HARNETT CO DSS UPFIT 2ND FLOOR
HARNETT COUNTY, NORTH CAROLINA

The following modifications and clarifications are hereby made a part of the Bidding Documents and supersede or otherwise modify the provisions of the published *Project Manual* and *Drawings*, dated February 7, 2024.

END OF ADDENDUM NO 01

SECOND FLOOR FINISH PLAN

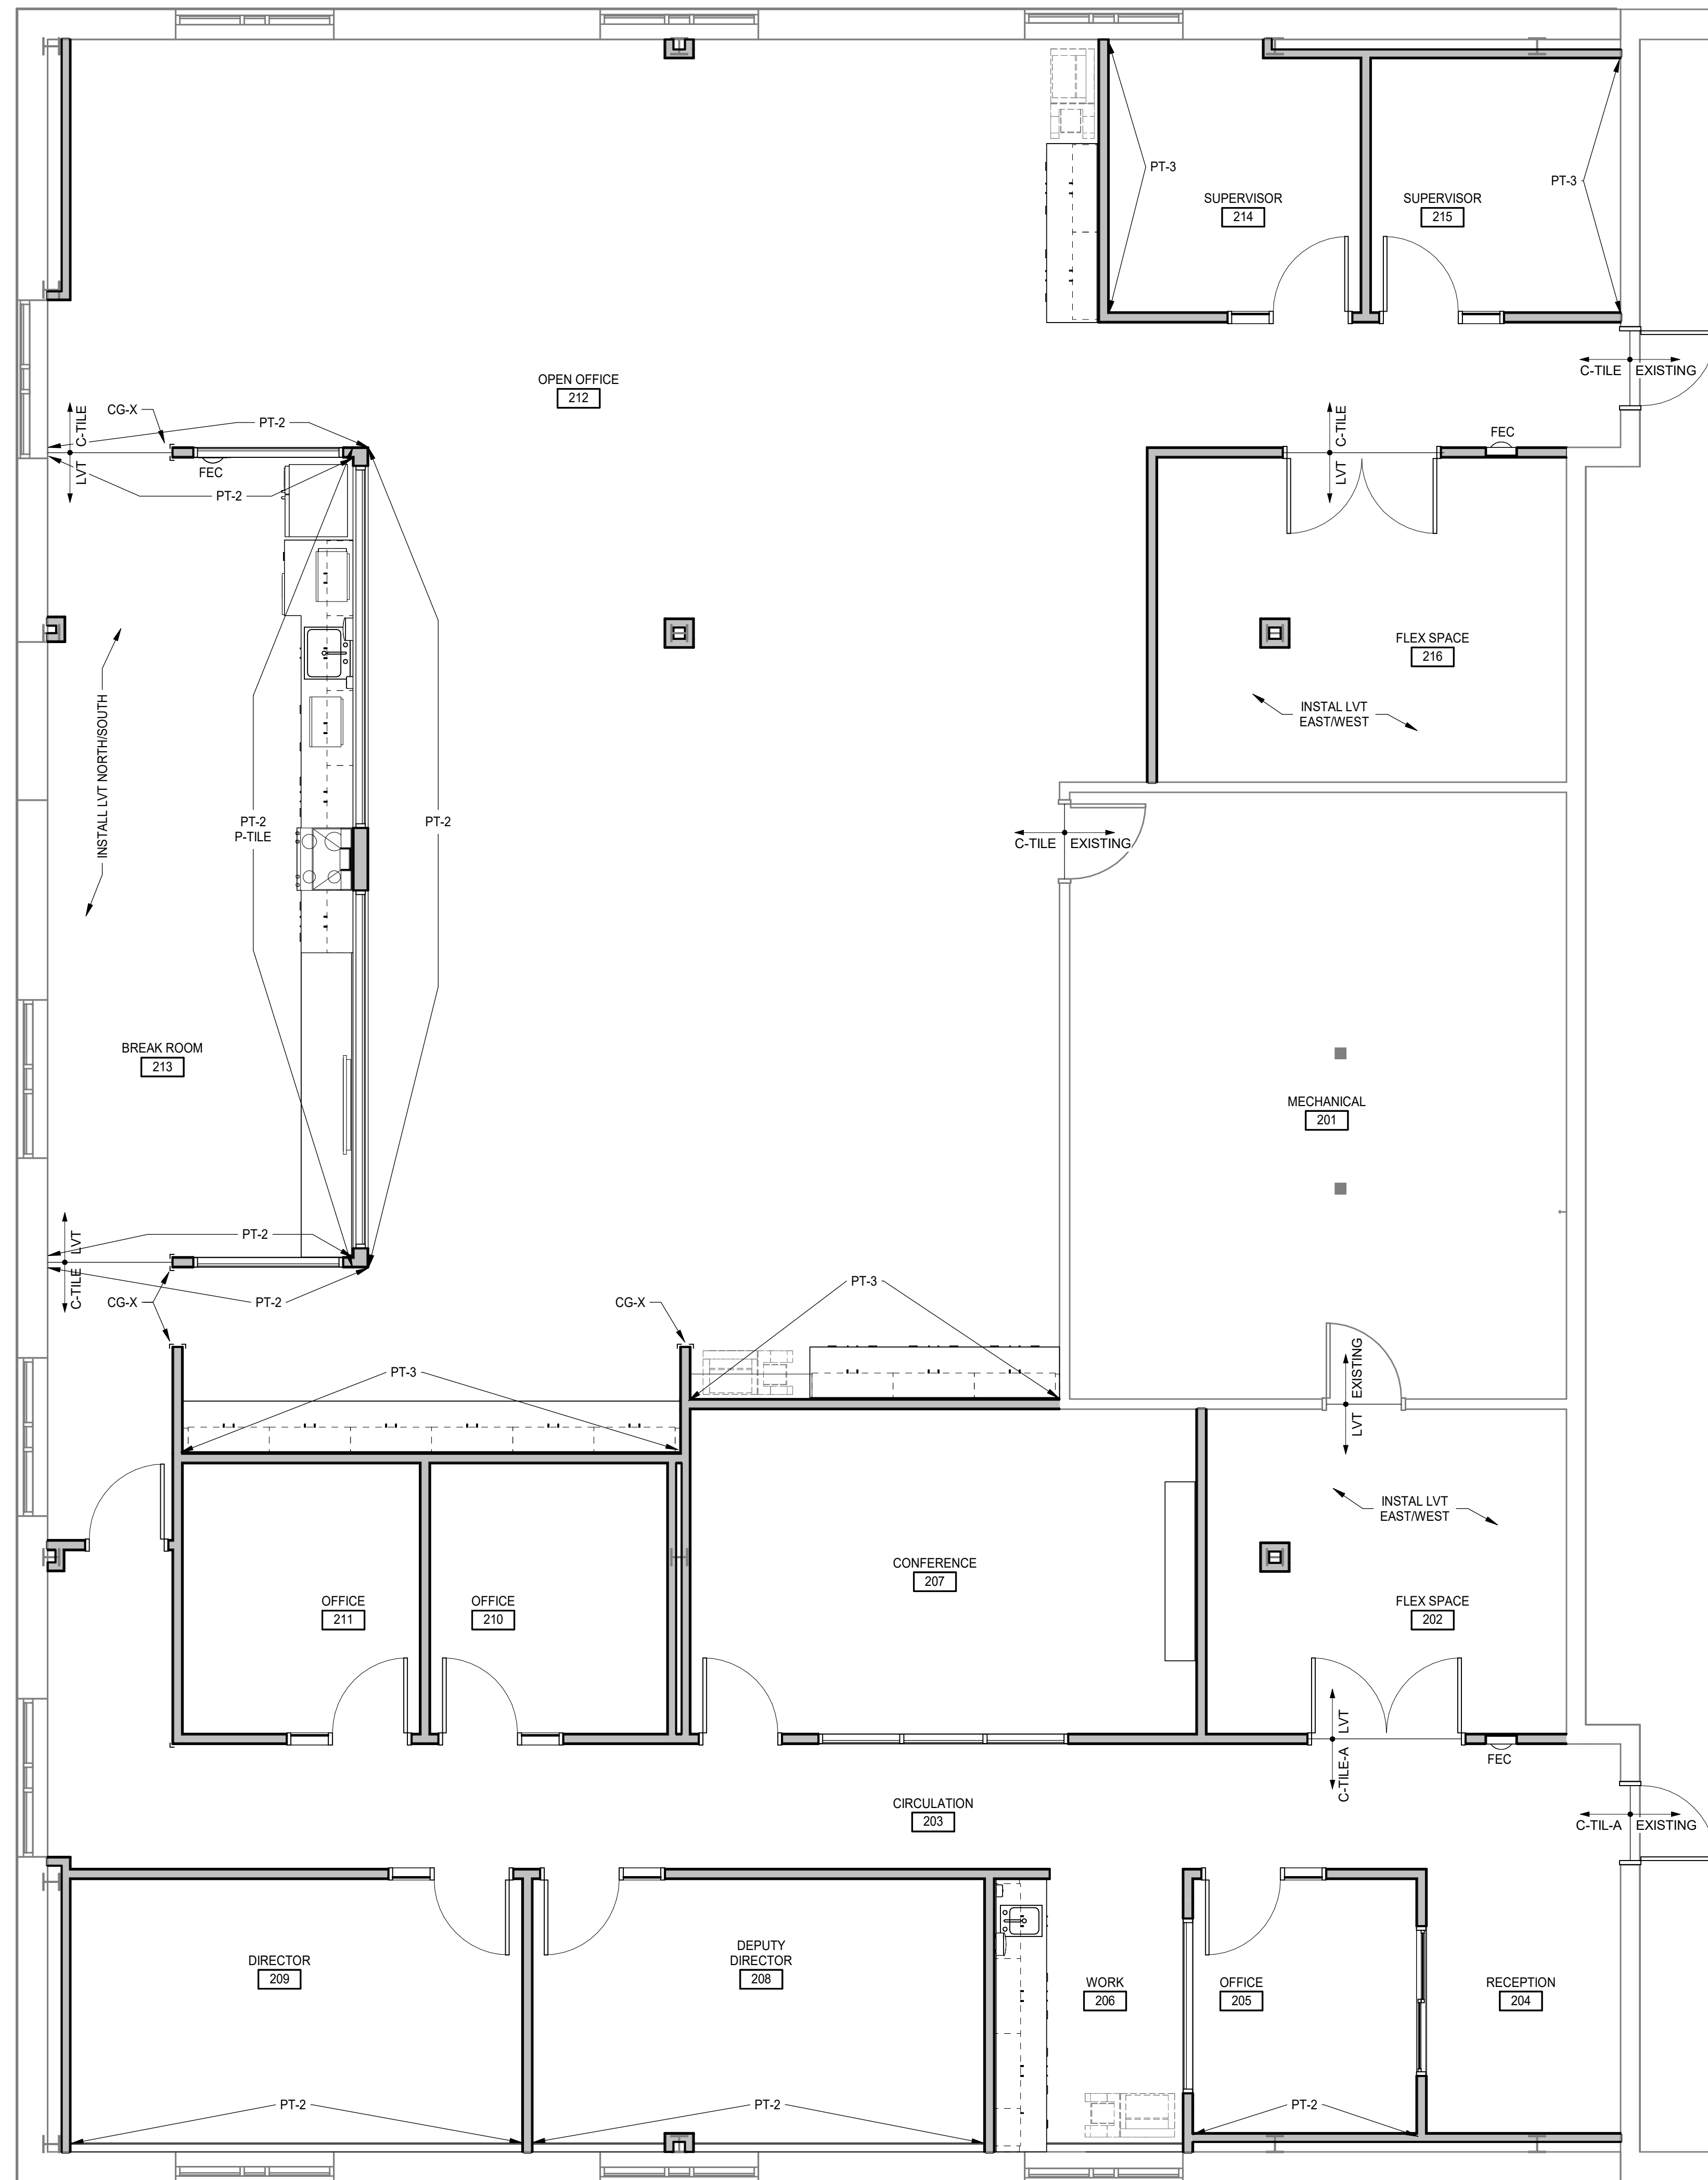
DRAWING A3.0.1
